August 28, 1992
LD-92-091

Docket No. 52-002

Subject: System 30+™ Severe Accident Features

Reference: NRC Letter, Severe Accident Design Features, April 9, 1992

Figure 3.1-3: Comparison of Fragility Curves for System 80+

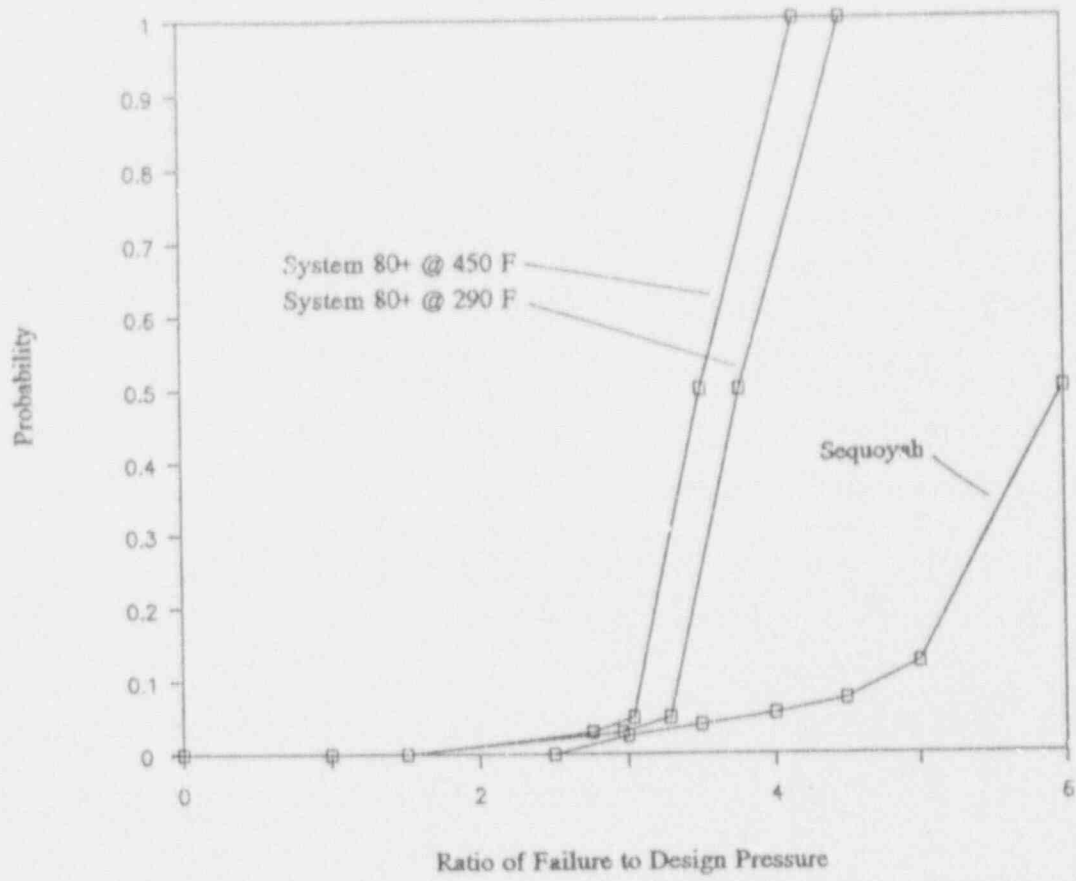
Q. 410.163 In accordance with SECY-90-016, the design pressure used for severe accident analysis may be calculated one of two ways-- either applying a conditional containment failure probability (CCFP) guideline of 0.1, or using a deterministic method (based on the ASME schedule) offering comparable protection. Therefore, please provide the following:

The System 80+ Probabilistic Risk Assessment documented in Appendix B of CESSAR-DC shows that the conditional probability of containment failure given a core melt condition was 0.099. This result was obtained using containment fragility (probabilistic failure) data generated for the PRA. Fragility data based on more detailed analyses has been recently generated. This data is presented in Figure 3.1-3 of Reference 1 and would be used in the revised System 80+ PRA.

FIGURE 4.2-2: PROJECTED BASEMAT EROSION PROFILES FOR SYSTEM 80+ AT 48 HRS FOLLOWING INITIAL BASEMAT CONTACT

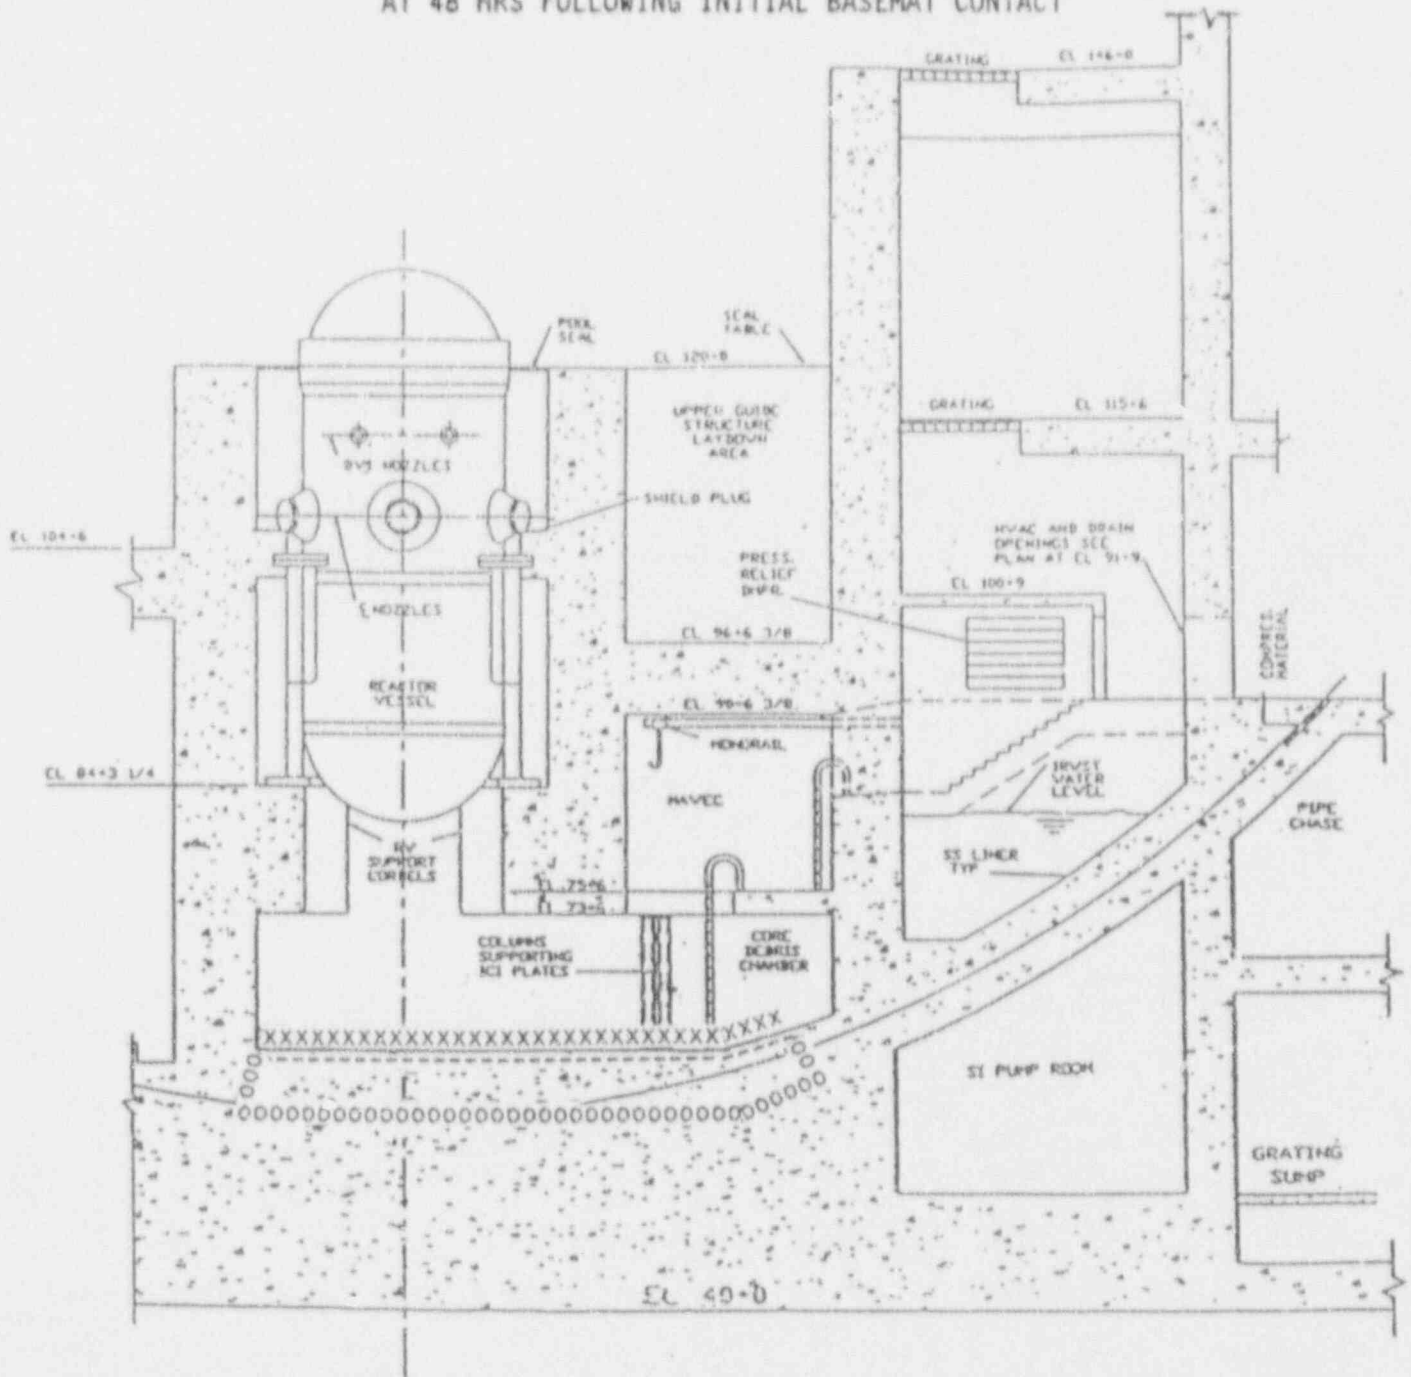
- h. What total thickness was assumed for the basemat?
 - i. Please provide the supporting containment pressure temperature response profile.
 - j. Please provide a plot of the integrated and instantaneous production rate of non-condensable gases as a function of time.

MAAP analyses performed to parametrically study degraded debris heat removal indicate that the maximum concrete erosion that can be expected in a "wet" cavity is 0.75 foot (See response to Q. 410.164). Erosion of limestone/common sand concrete to a 0.75 foot depth would release approximately 19,000 lbm of carbon dioxide to the containment atmosphere. Release of carbon dioxide due to erosion of a basaltic basemat is small (approximately 1300 lbm).
